**TOWN OF NEWBURGH  
PLANNING BOARD  
TECHNICAL REVIEW COMMENTS**

**PROJECT NAME: HAMPTON INN & SUITES**  
**PROJECT NO.: 14-16**  
**PROJECT LOCATION: SECTION 95, BLOCK 1, LOT 45.12**  
**REVIEW DATE: 29 JANUARY 2015**  
**MEETING DATE: 5 FEBRUARY 2015**  
**REPRESENTATIVE: MASER CONSULTING**

Re: Hampton Inn & Suites  
Section 95, Block 1, Lot 45.12  
Town of Newburgh, Orange County, New York  
MC Project No. 12000031B

**STORMTECH SC-740 CHAMBER (SUBSURFACE SYSTEMS)**

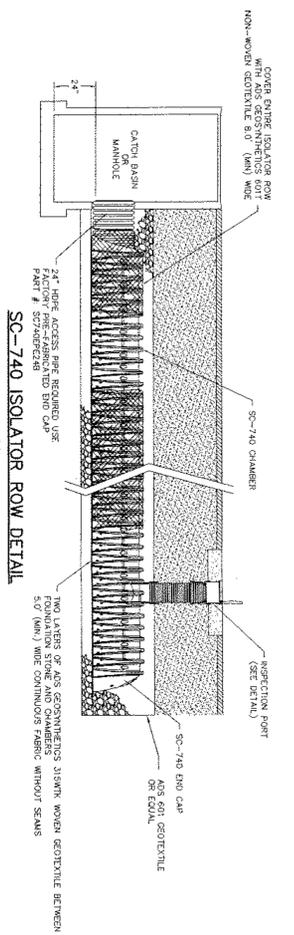
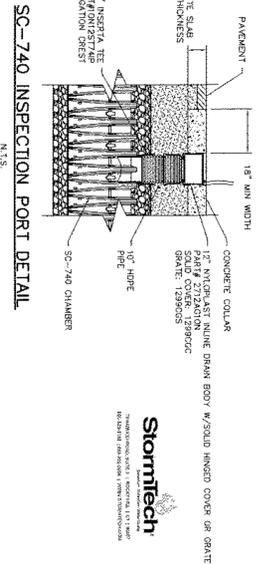
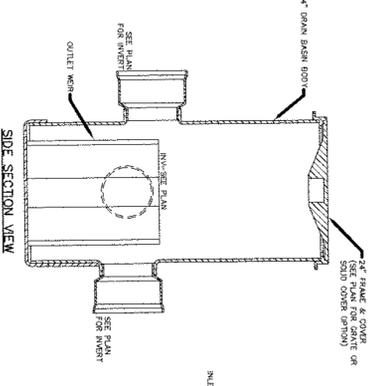
7. Each of the individual storm tech systems should give details for the inlet and outlet of the infiltration systems.
